CERTIFICATE OF APPROPRIATENESS

Property: 400 Cordell Street, Lot 5 and 6, Tract 1, Block 26, Brooke Smith Subdivision. The property includes a historic one-story wood frame 1,209 square foot single-family residence and a detached garage situated on a 5,000 square foot (50' x 100') corner lot.,

Significance: Whitaker-Graliano-Brown House is a City of Houston Protected Landmark designated in September of 2013. The Bungalow-style one-story historic residence was constructed circa 1918.

Proposal: Alteration – *Revision* The applicant was granted a Certificate of Appropriateness in May of 2014 to construct a two story addition to the rear of a one story Protected Landmark. The applicant now proposes the following revisions:

SOUTH SIDE ELEVATION

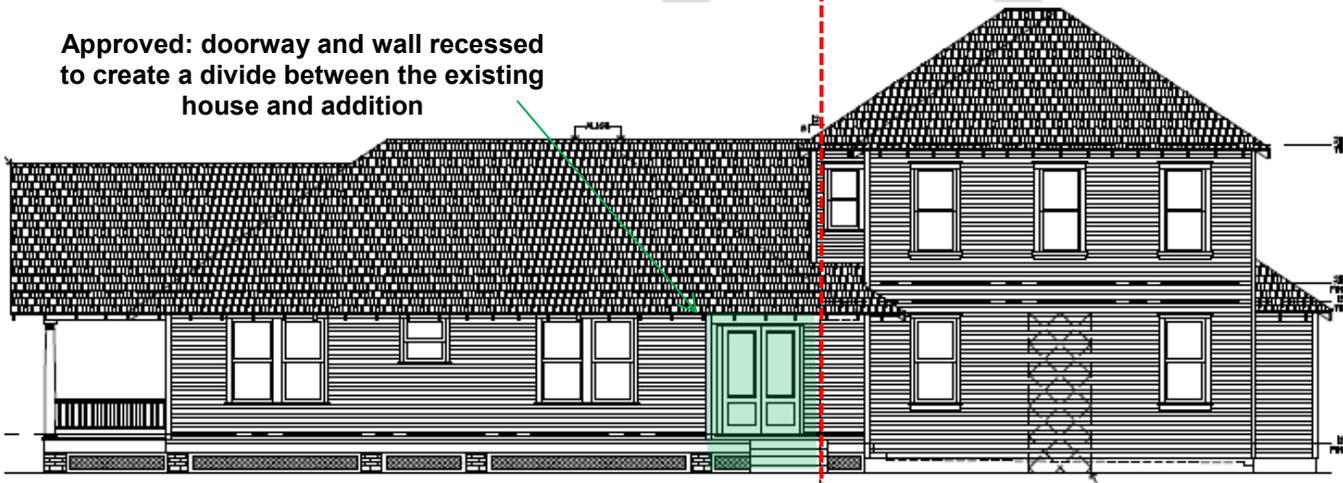
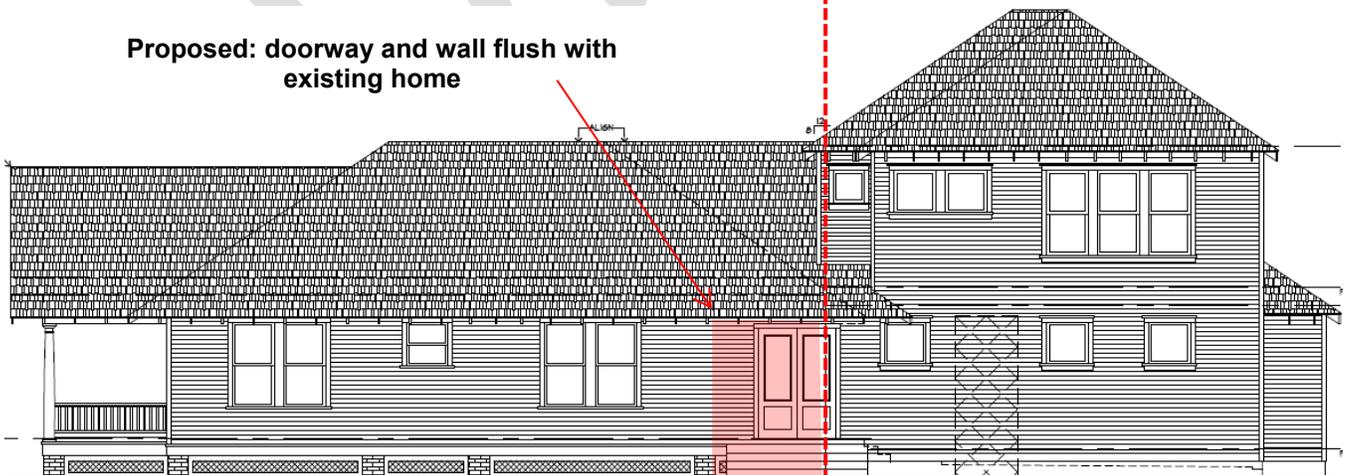
<i>The proposed replacement of an approved side facing porch with a flush wall removes the delineation between the existing residence and proposed two story addition. The more unified appearance of the two masses is not consistent with the character of the Protected Landmark.</i></p> |

Approved: doorway and wall recessed to create a divide between the existing house and addition

Proposed: doorway and wall flush with existing home

NORTH SIDE ELEVATION

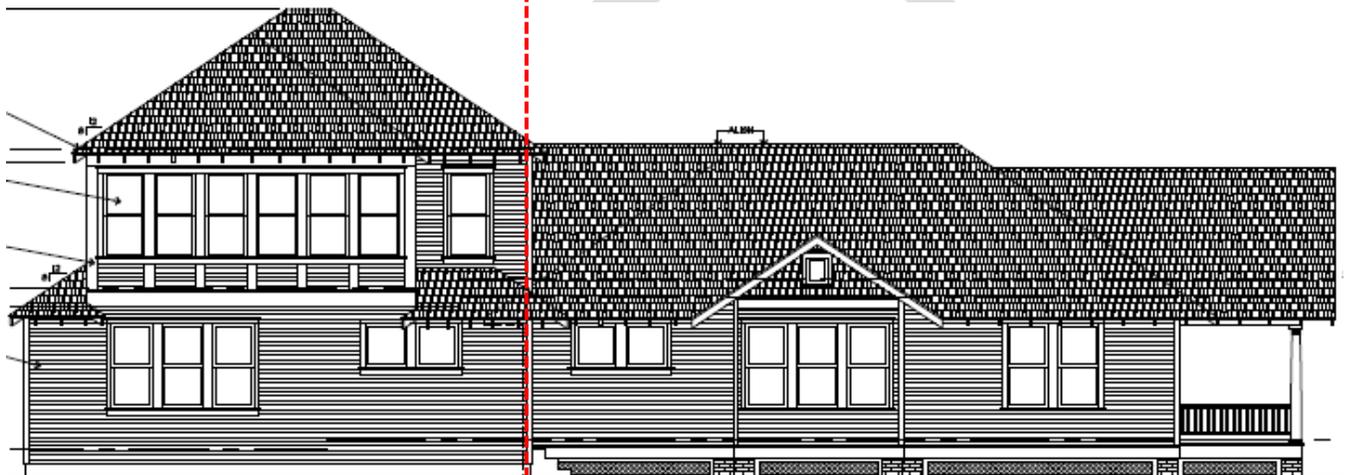
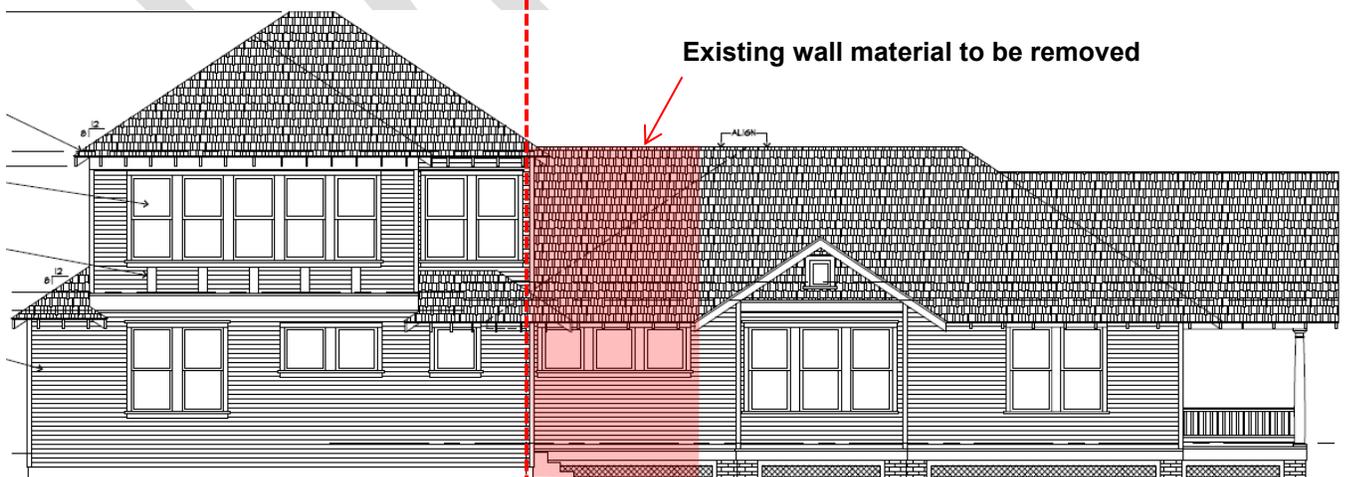
<i>The proposed removal of a section of the rear north facing exterior wall, combined with the approved construction of a two story rear addition, undermines the essential form and integrity of the existing structure.</i></p> |

Existing wall material to be removed

**FIRST FLOOR PLAN
EXISTING**

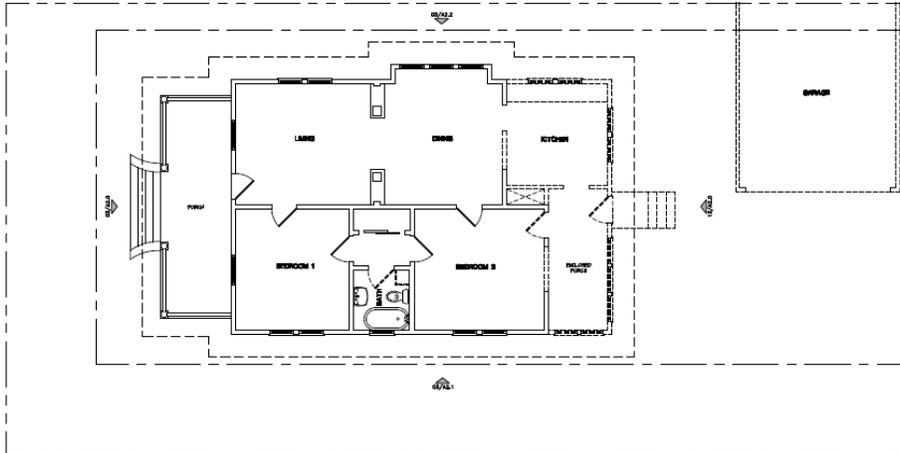
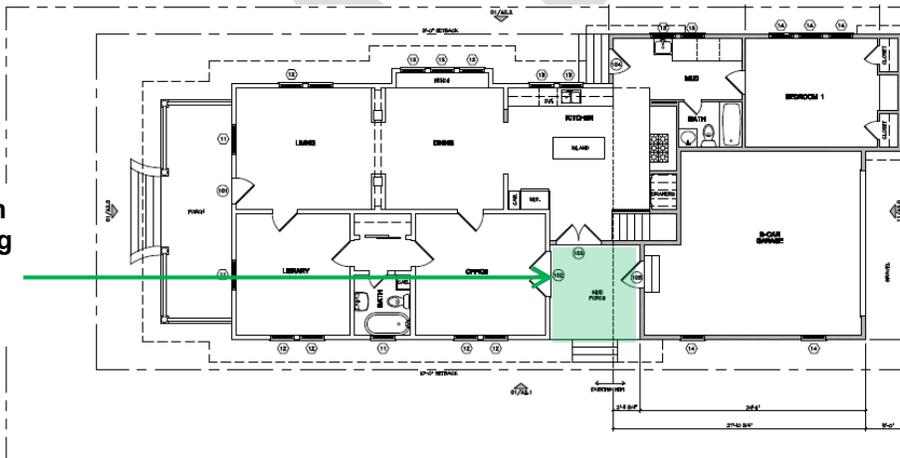
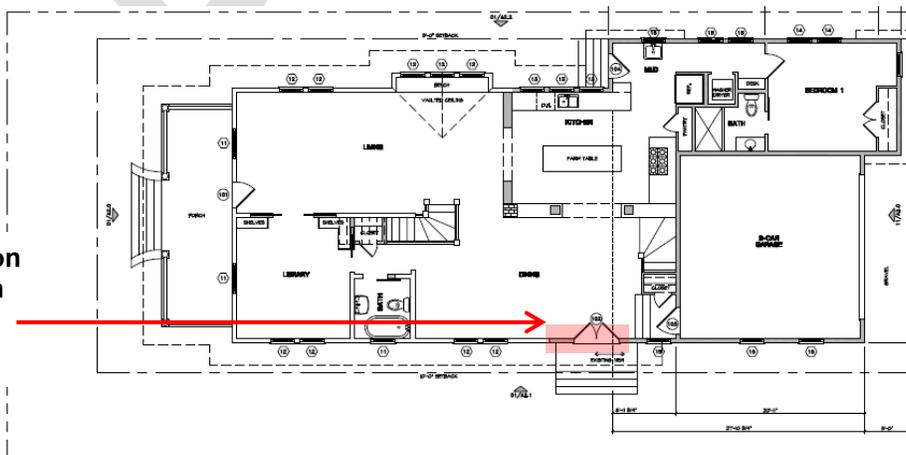
Approved: open porch separating addition from existing home

Proposed: Addition wall is flush with the existing structure

The applicant now proposes to undo this feature by starting the addition over the existing enclosed porch, resulting in a flush wall connecting the two masses.

HISTORIC WALL MATERIAL TO BE REMOVED
NEW WALL MATERIAL SHADED IN GREY

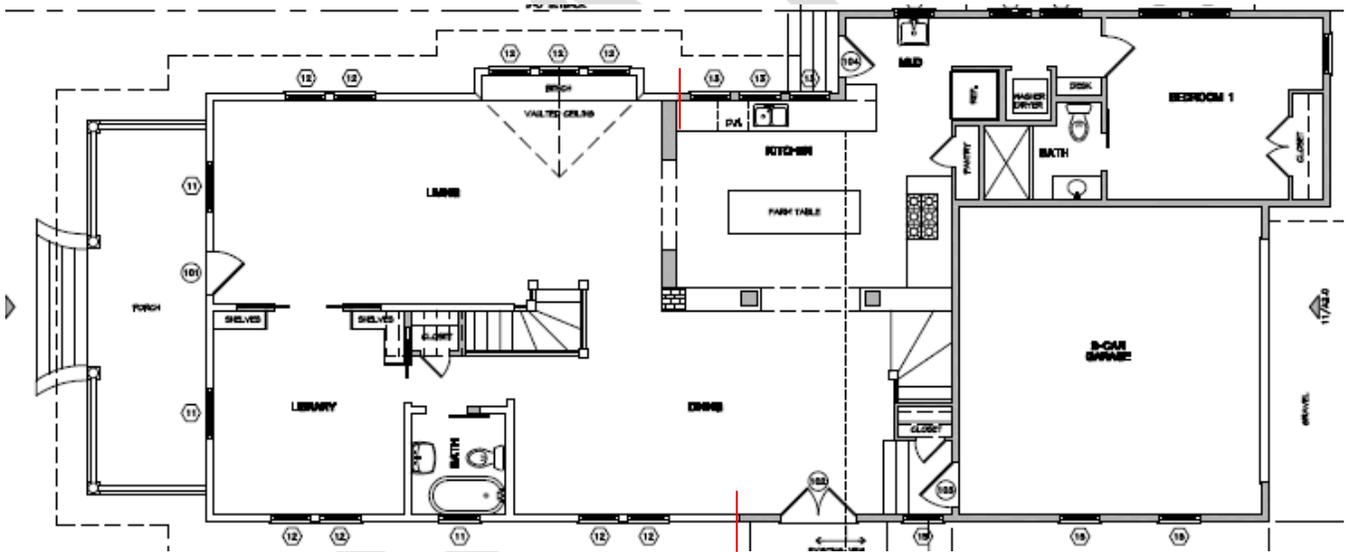
Exterior Materials: The approved addition began at the rear wall of the structure, keeping the front and side exterior walls intact. The applicant now proposes to remove a section of the north facing exterior wall, between the north facing bump out and the existing rear wall. This will be replaced with new wall material.
